Re: DSUP #2016-0009, Completeness
Patrick Henry School & Rec Center, 4643 Taney Avenue

This letter serves to inform you that City staff has completed review of the materials submitted for the above referenced Development Completeness plan set. The plans have been deemed incomplete. The attached comments are based upon the plans submitted August 11, 2016. Please respond to each of the attached comments in writing and revise the plans as necessary.

The plans are deemed incomplete.

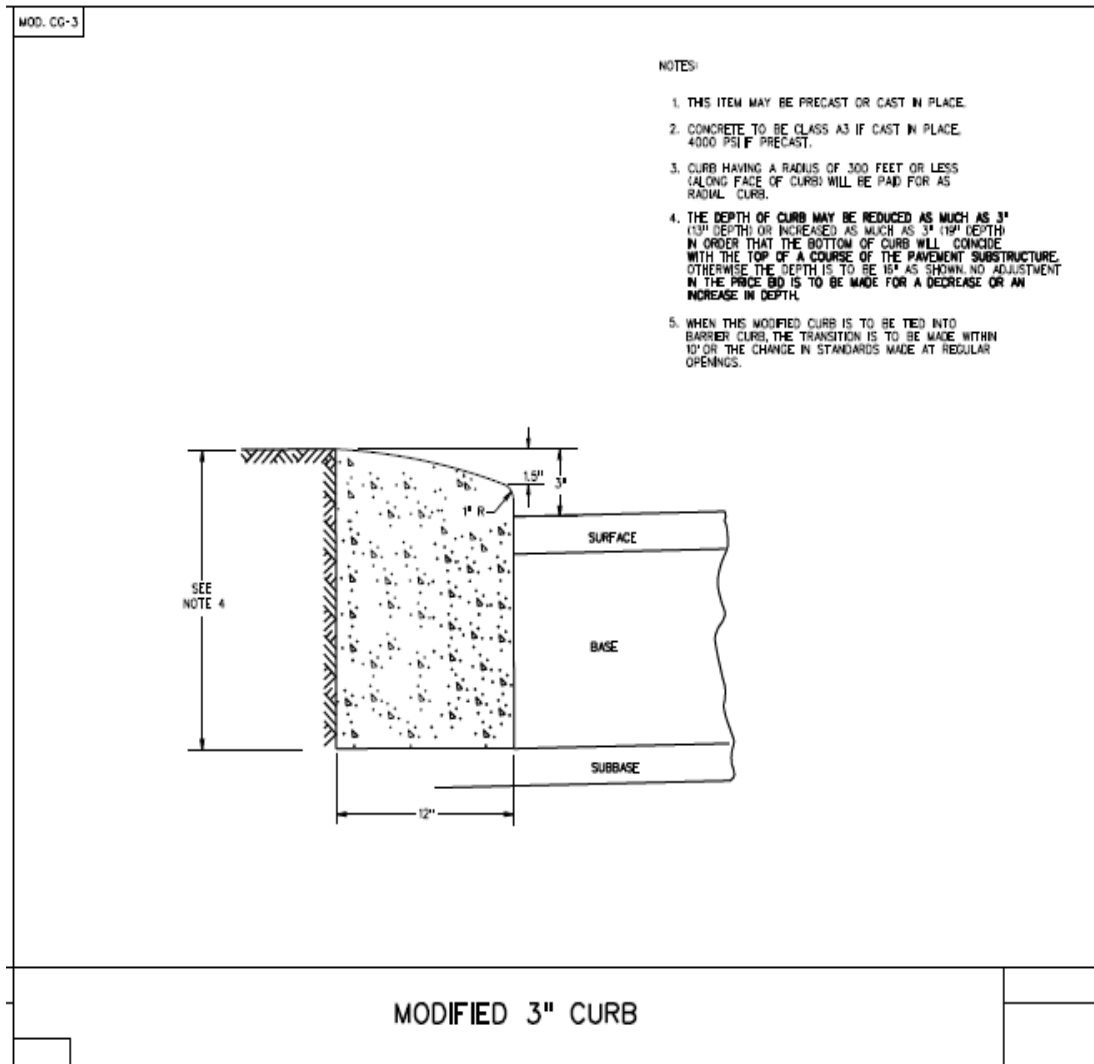
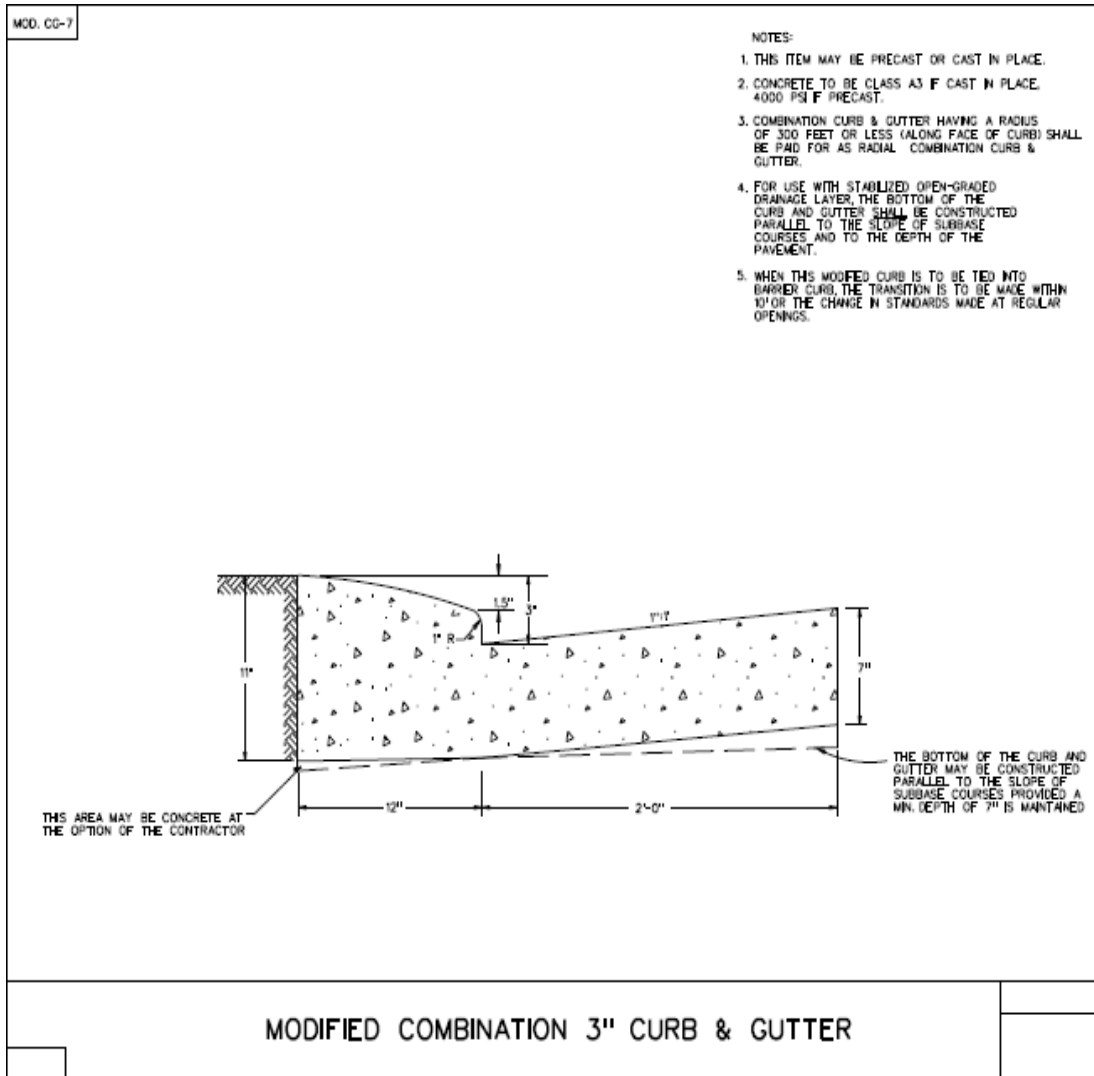
83. The fire service plan shall show placement of emergency vehicle easement signs. See sign detail and placement requirements are as follows:

Emergency vehicle easements shall be a minimum of 22 feet across the travel lane. The emergency vehicle easement shall provide access to strategic areas of the building and fire protection systems. Curbing and street components shall conform to the standards established by Transportation and Environmental Services and this document for emergency vehicle easements.

Emergency vehicle easement signs shall be metal construction, 12-inches wide and 18 inches in height. Provide red letters on reflective white background with a 3/8-inch red trim strip around the entire outer edge of the sign. The lettering shall say "NO PARKING," "EMERGENCY VEHICLE EASEMENT," "EM. VEH. EAS," and "City of Alex.," Lettering size shall be as follows: "NO PARKING" - 2 inches, "EMERGENCY VEHICLE EASEMENT" - 2½ inches. EM. VEH. EAS. - 1 inch, CITY OF ALEX. - ½ inch. Directional Arrows - 1 inch by 6 inches solid shaft with solid head - 1½ inches wide and 2 inches deep (For examples, see Figures D102.1, D102.2, and D102.3). Signs shall be mounted with the bottom of the sign 7 feet above the roadway, and shall be properly attached to a signpost or other approved structure such as designated by the fire official. Posts for signs, when required, shall be metal and securely mounted. Signs shall be parallel to the direction of vehicle travel and posted so the directional arrows clearly show the boundaries and limits of the Emergency Vehicle Easement. In areas where emergency vehicle easements involve two-way traffic, double mounted signs shall be provided. The maximum distance between signs shall be 100 feet. Other special signs or modifications to emergency vehicle easement signs shall be approved by the fire official.

Where curbing is a component of the emergency vehicle easement, the curbing construction shall conform to weight and grade requirements for vehicular traffic. In no circumstances shall a raised curb be located in the path of travel in an emergency vehicle easement. Where a mountable curb is provided as part of an emergency vehicle easement, emergency vehicle easement signs shall be posted at the point nearest the edge of the emergency vehicle easement, but in no case within the clear width of the emergency vehicle easement. With the exception of flush curbs, any fire department access points that require fire apparatus to mount a curb shall conform to the modified 3 inch curb design standard MOD CG-3 or MOD CG-7 design as shown.

Information will be provided at preliminary submittal. Applicant has employed CG 7 at two locations.
